Figure 14: Building Height Control Plan

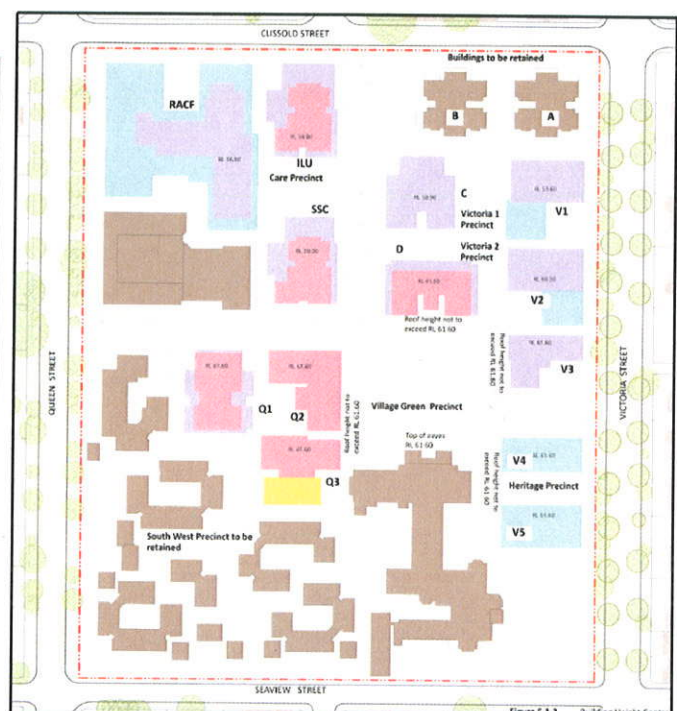
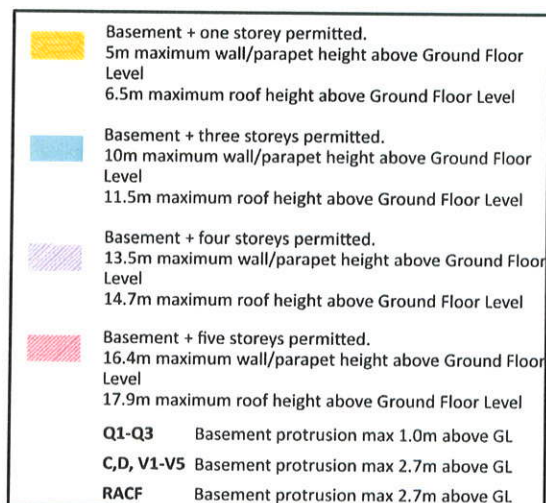
The Proponent has stated that the proposed building height has been established to correspond with the fall of the land to ensure that no one building will dominate the site. This is illustrated by **Figures 14, 15 and 16** which show that all new buildings will sit below RL 61.600m, the eave height of Glentworth House and the Chapel.

The proposed buildings outlined within the last three stages of the Concept Plan (3,4 and 5) increase in height from 3 to 4 storeys as they move northwards away from the historic buildings. This height increase corresponds to the topography of the site where the land falls towards the north as illustrated by **Figures 14, 15 and 16** below.

Despite the Concept Plan proposing to substantially increase the overall volume and mass of structures within the village, the Department considers that the site is of sufficient size to absorb the proposed height increases and minimise any negative impacts upon the character of the locality including nearby heritage items. The building heights as proposed within the Concept Plan have been distributed across the site to form an appropriate transition between the proposal and the existing residential development surrounding the site.

Figure 15: Cross Section of Victoria Street (as proposed with Concept Plan)

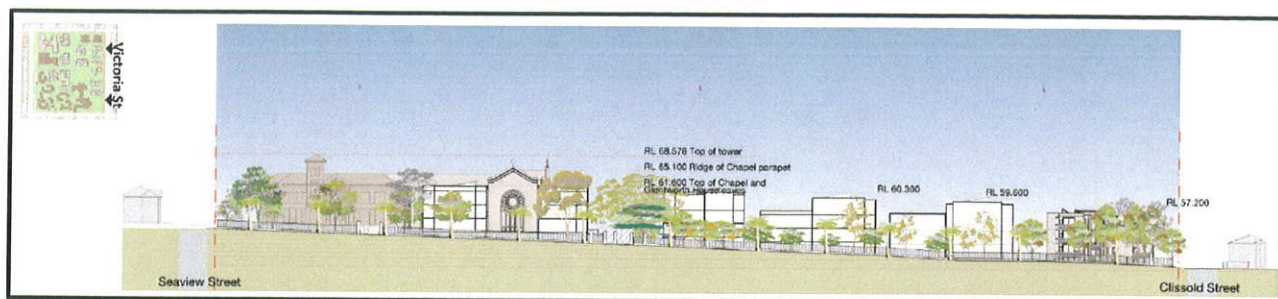
To minimise the impact of the increased height and building mass on the site, the tallest and largest elements of the proposal are located centrally away from the street frontage as illustrated by **Figure 15**. The largest built forms proposed within the Concept Plan are those included within the Project Application for stages 1 and 2.

Figure 17: Proposed Building Separation and Building Widths

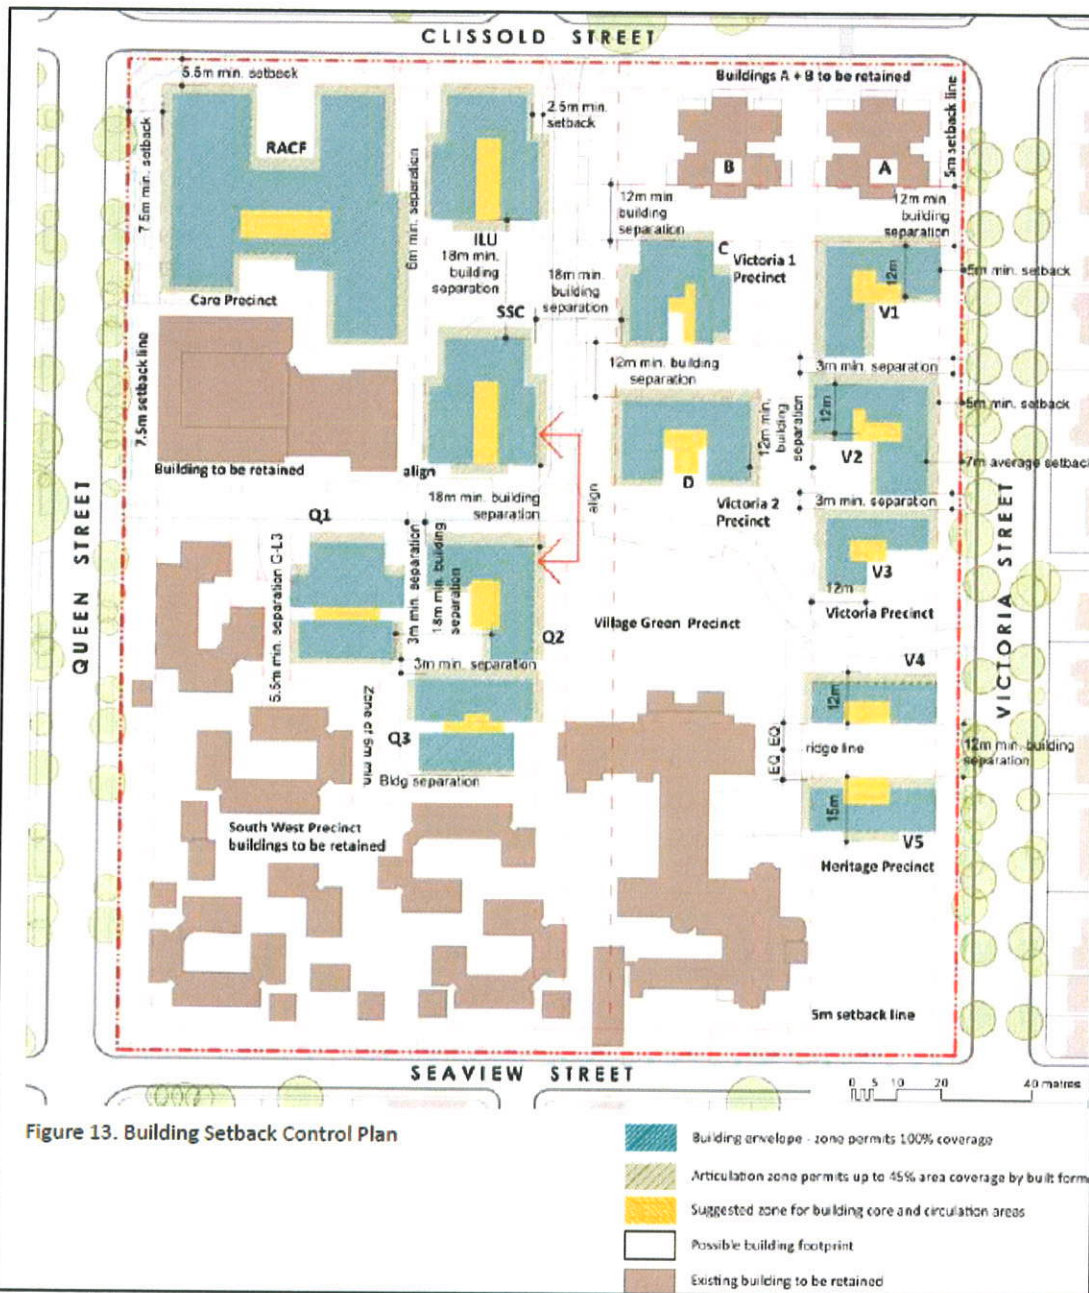
The separation of the Stage 1 buildings ranges between a minimum of 3 metres to 18 metres.

The narrowest separation is created by the entry ways between the buildings to access the central courtyard. Although the building separation is below RFDC requirements (as outlined above), the windows and balconies have been positioned to prevent direct overlooking between the residential units, and achieve appropriate access to sunlight and daylight. At ground level, the ILU's are adequately protected from overlooking from communal areas by generous landscaped areas and setbacks.

The separation between the RACF and the ILU's falls 6 metres short of the suggested 12 metre separation. However, to ensure that the development satisfies the objectives of the relevant code requirements and to mitigate any overlooking opportunities, the windows on the eastern side of the RACF will be fitted with privacy shutters and balconies on the western sides of the ILU's will include privacy screens which will prevent any direct overlooking between the buildings.

In addition, the Department considers that the proposed building separation is consistent with those of the Concept Plan (**Figure 17** above) and the established building separation in the locality. However, to ensure that adequate privacy levels occur, a condition requiring further details of the proposed privacy screens prior to construction has been recommended (Condition B9).
